Addendum No. 1 to IFB 27-17

To: Bidders of IFB 27-17 East Somerville Community School Façade Stabilization

Re: Questions and Responses

SHEET COVER

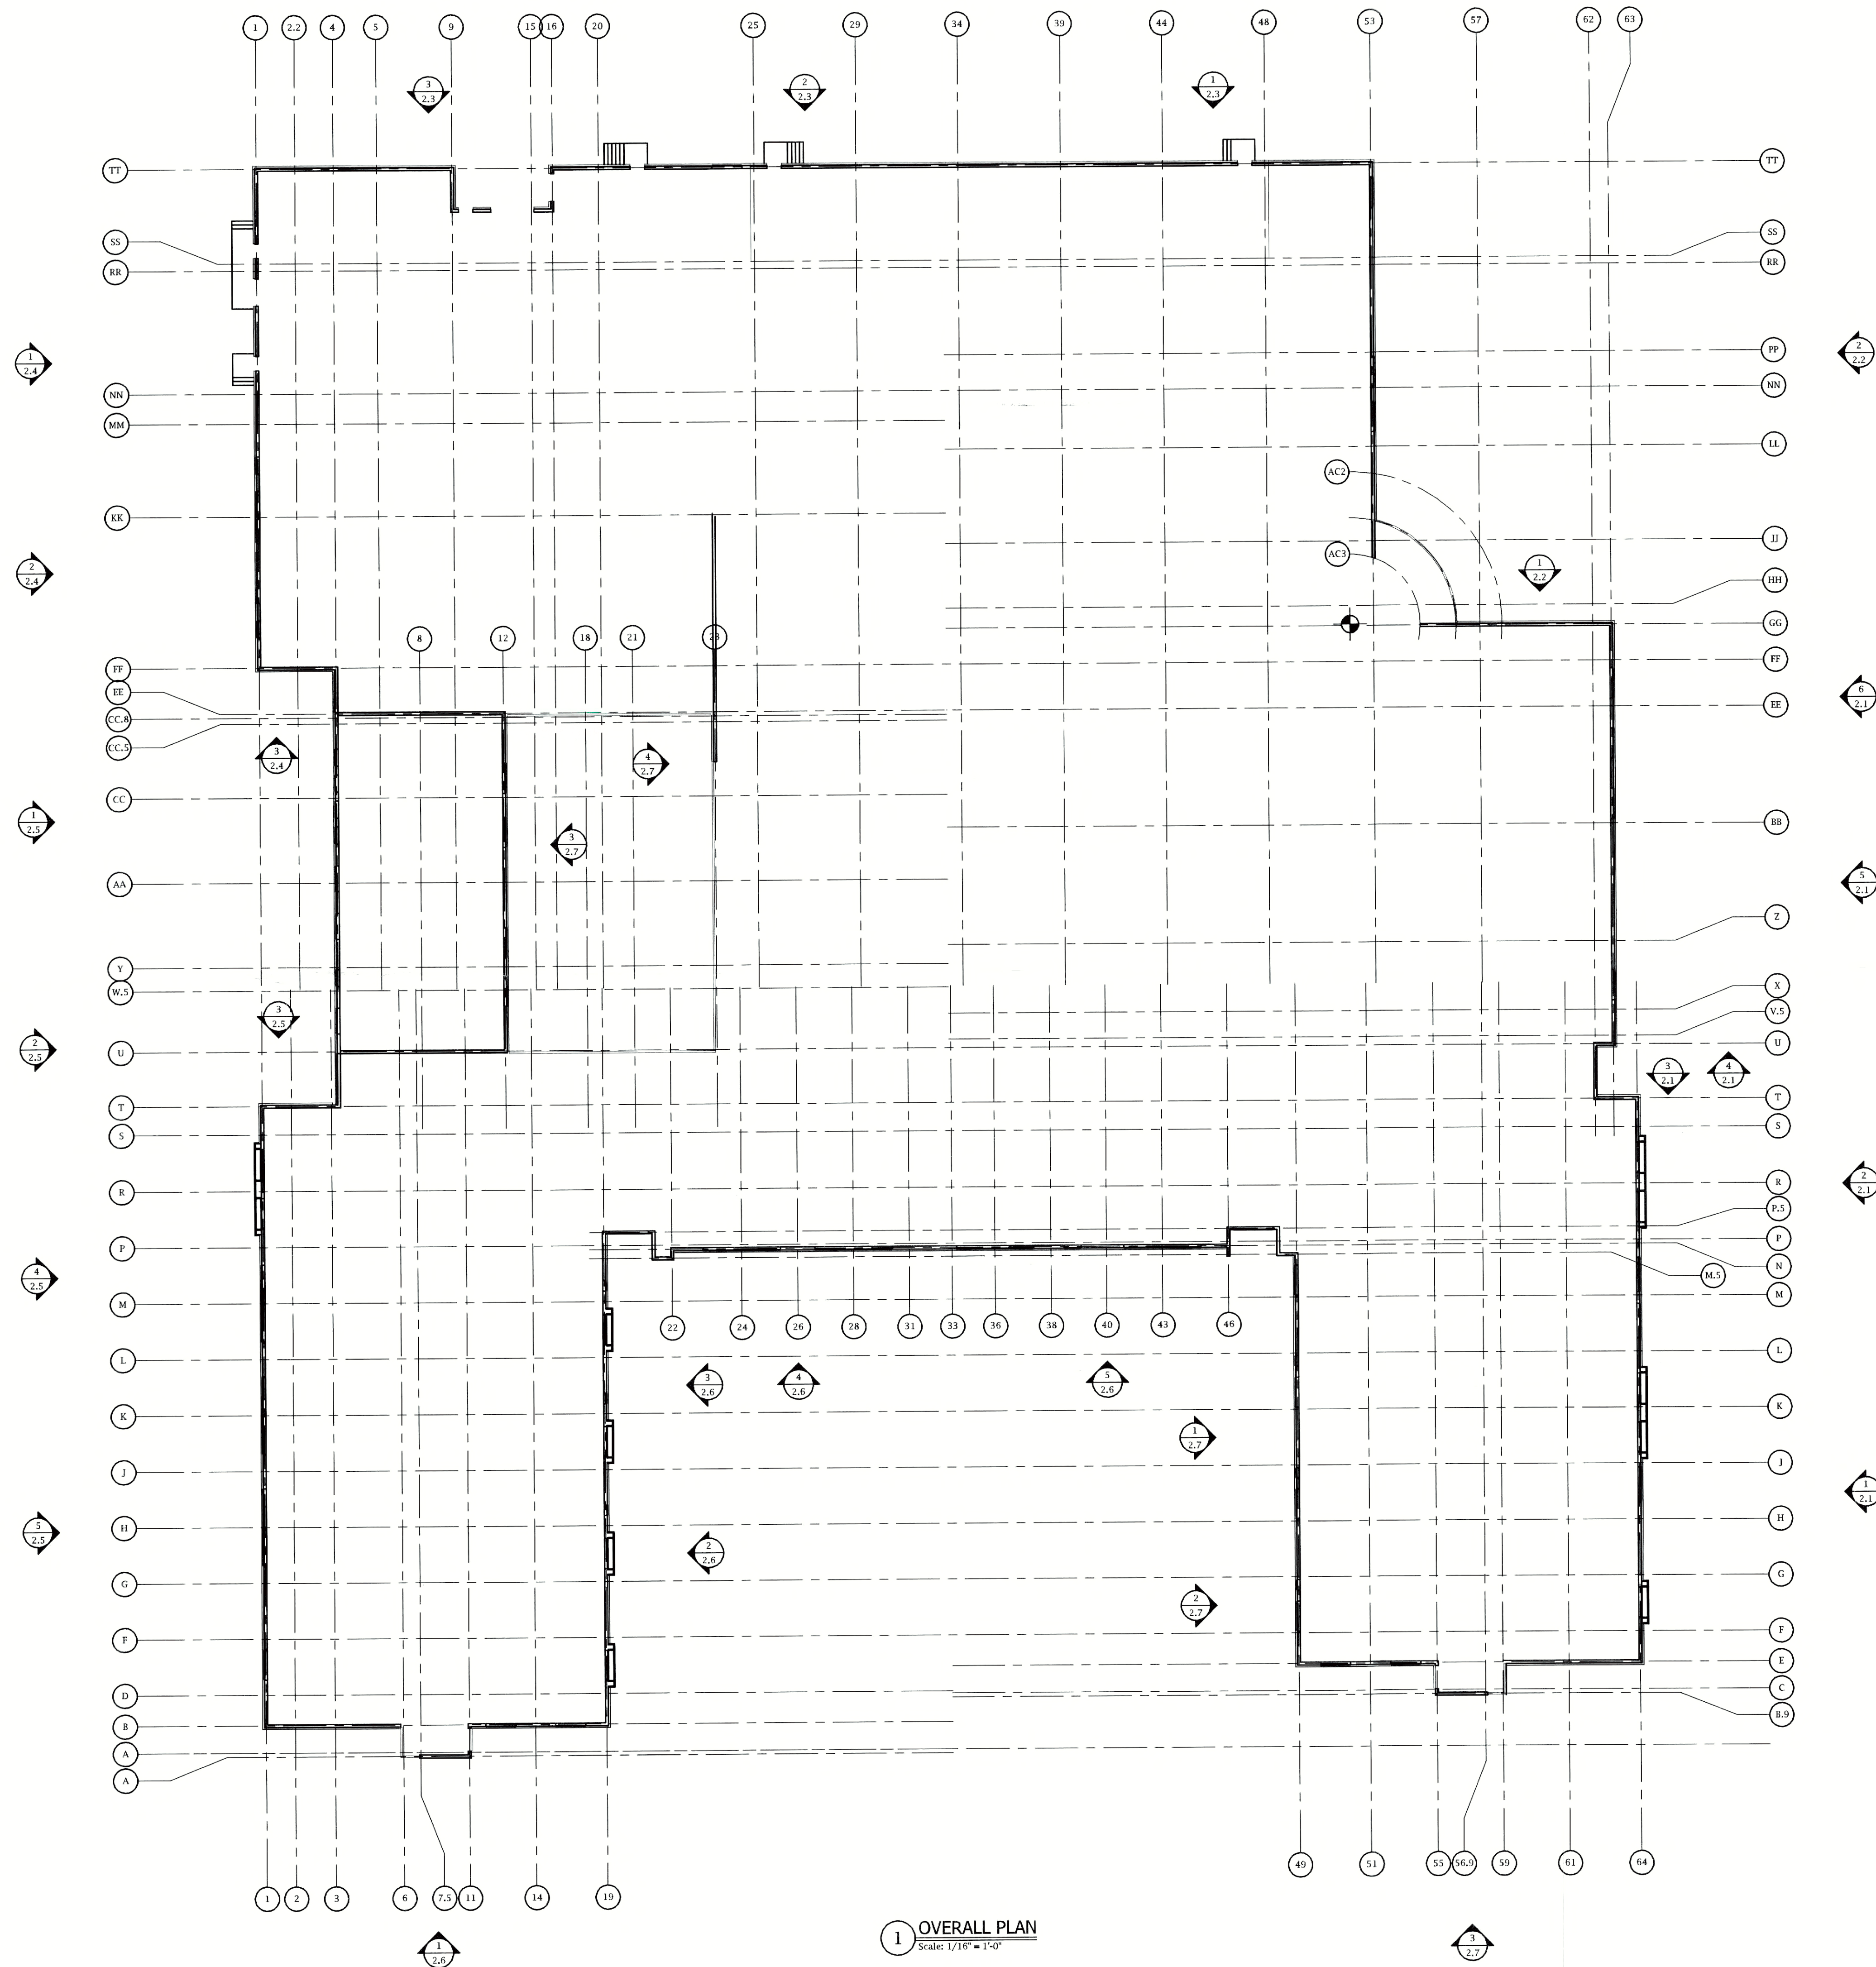
NER to incorporate changes to North Elevation per PR #001.
Ground face CMU will NOT be incorporated - A/E confirm dolomitic limestone per contract will remain.
